UNITED STATES PATENT AND TRADEMARK OFFICE

APPLICATION NO.	FILING DATE	FIRST NAMED INVENTOR	ATTORNEY DOCKET NO.	CONFIRMATION NO.
10/582,198	06/09/2006	Yang Shen	0002860USU/4137	3977
27623	7590	06/09/2009	EXAMINER	
OHLANDT, GREELEY, RUGGIERO & PERLE, LLP			FULTON, KRISTINA ROSE	
ONE LANDMARK SQUARE, 10TH FLOOR				
STAMFORD, CT 06901			ART UNIT	PAPER NUMBER
			3673	
			MAIL DATE	DELIVERY MODE
			06/09/2009	PAPER

Office Action Summary	Application No.	Applicant(s)	
	10/582,198	SHEN, YANG	
	Examiner	Art Unit	
	KRISTINA R. FULTON	3673

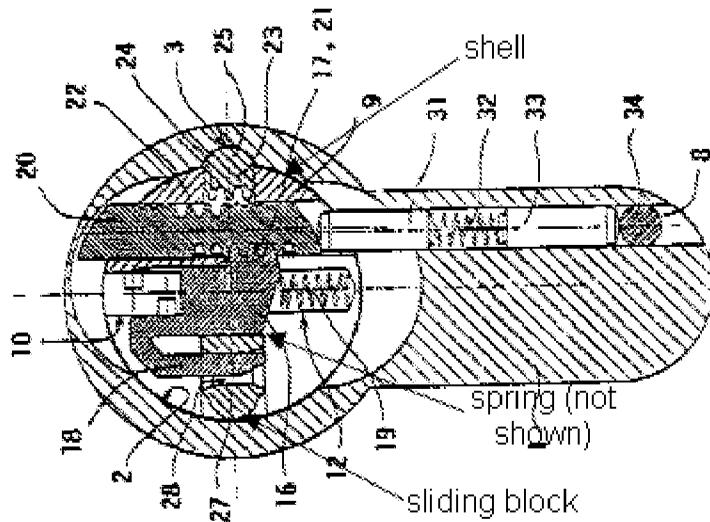
toothed piece into the engaged position (figure 18), so that the block groove allows retraction of the locking block into the lock cylinder, wherein rotation of the first key in turn rotates the lock cylinder, the locking block retracts into the lock cylinder sliding into the blocking groove (figure 19), wherein retraction of the locking block into the lock cylinder prevents the toothed piece from moving (column 7, lines 14-17), and slides the sliding block linearly in a direction perpendicular to the rotational axis to disengage the toothed slide from the toothed piece (27 moves perpendicular to the axis as shown in figures 18 and 19), and wherein removal of the first key and insertion of a second key moves the toothed slide (figure 21) to establish a new engagement position between the toothed slide and the toothed piece, so that the second key now locks and unlocks the key changeable lock (column 7, lines 22-26). Please note that although Loreti does not specifically state that the lock block directly prevents rotation of the lock cylinder, this is obvious from the figures of Loreti. See figures 2, 12 and 17, where the cylinder (9) can not possibly rotate while the locking block (23) is in the housing (at 3). One skilled in the art would know from the figures and from common practice in the art that the locking block (23) directly prevents rotation of the cylinder (9). See the Loreti device below.

10. Regarding claim 13, springs (30) are between the sliding block and a shell (the entire outer edge surface of cylinder 9; see figure labeled above) to bias the sliding block and the toothed slide into the engaged position (as shown in figure 17).

11. Regarding claim 14, a compression spring (30) is provided to bias the sliding block and in turn the toothed piece, when in the engaged position, to block retraction of the locking block. Please note that 30 biases 27 in figure 17 against the "shell" as labeled above causing engagement between the sliding block and toothed slide and the toothed slide and tooth piece blocking retraction of the locking block.

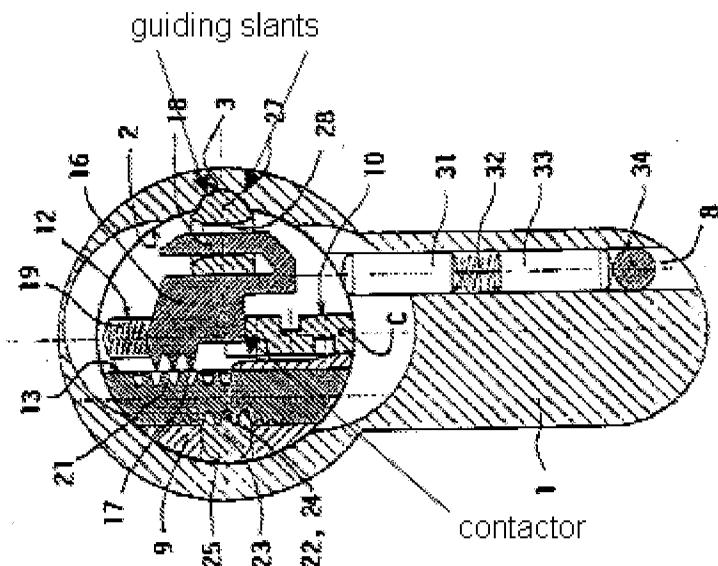
17. Regarding claim 20, a contactor (surface shown in figure labeled below) is fixed on the toothed slide and located within the locking hole to engage the second key.

Please note that "a contactor" is very broad and can be an portion "contacted" by the second key.

18. Regarding claim 21, the locking groove (3) is on the lock housing; when the locking block is located at the first working position, the locking block is received in the locking groove (figure 17); and each side face of the locking groove has a guiding slant (see slanted edges labeled in figure above).
